Access Compliance Report

Public Rights-of-Way

(Curb Ramps)

Intersection ID: 27121	Main Street: ELM_LN	Cross Street: ENDAHVEN_LN	Location: SW
ADA ID: 8108359F8AEB	Ramp Type: Para	Initial Pass/Fail: Fail	Overall Compliance: No
			Severity Score: 21.25

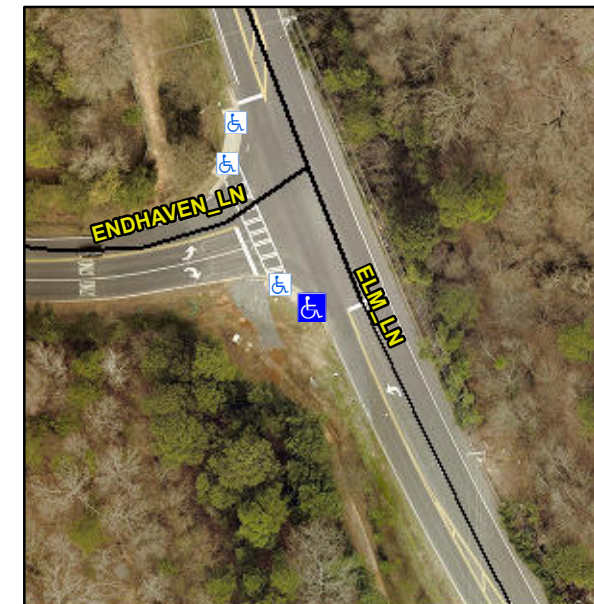
Surveyor Notes:

RT RP < 5%

PROW/ADA:

R304.5.1, R304.3.2

Possible Solutions:

Remove & Replace Entire Ramp.
